HINTON TERRACE SUBDIVISION, **RESUBDIVISION OF LOTS 6 & 7**

APPLICATION NUMBER 10 DATE November 4, 2004
APPLICANT Hinton Terrace Subdivision, Resub of Lots 6 & 7
REQUEST Subdivision

HINTON TERRACE SUBDIVISION, RESUBDIVISION OF LOTS 6 & 7

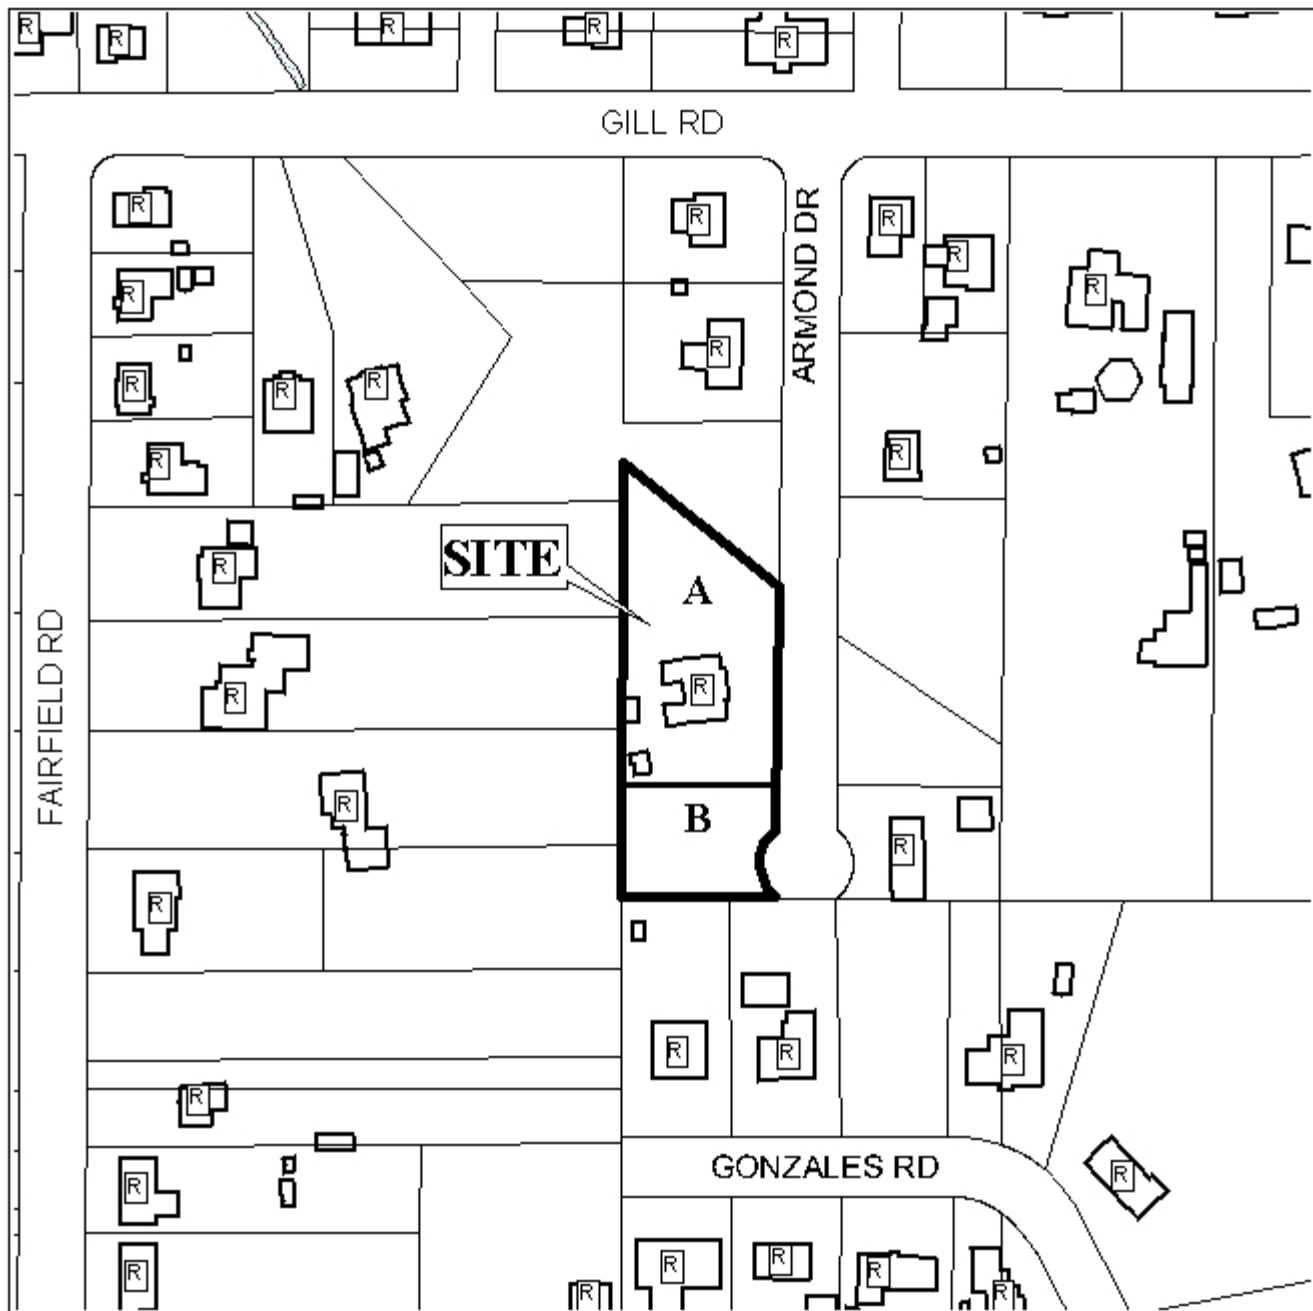
The 25-foot minimum building setback line is not shown but would be required on the final plat.

The plat meets the minimum requirements of the Subdivision Regulations and is recommended for Tentative Approval subject to the following condition: 1) the placement of the 25-foot minimum setback line on the final plat.
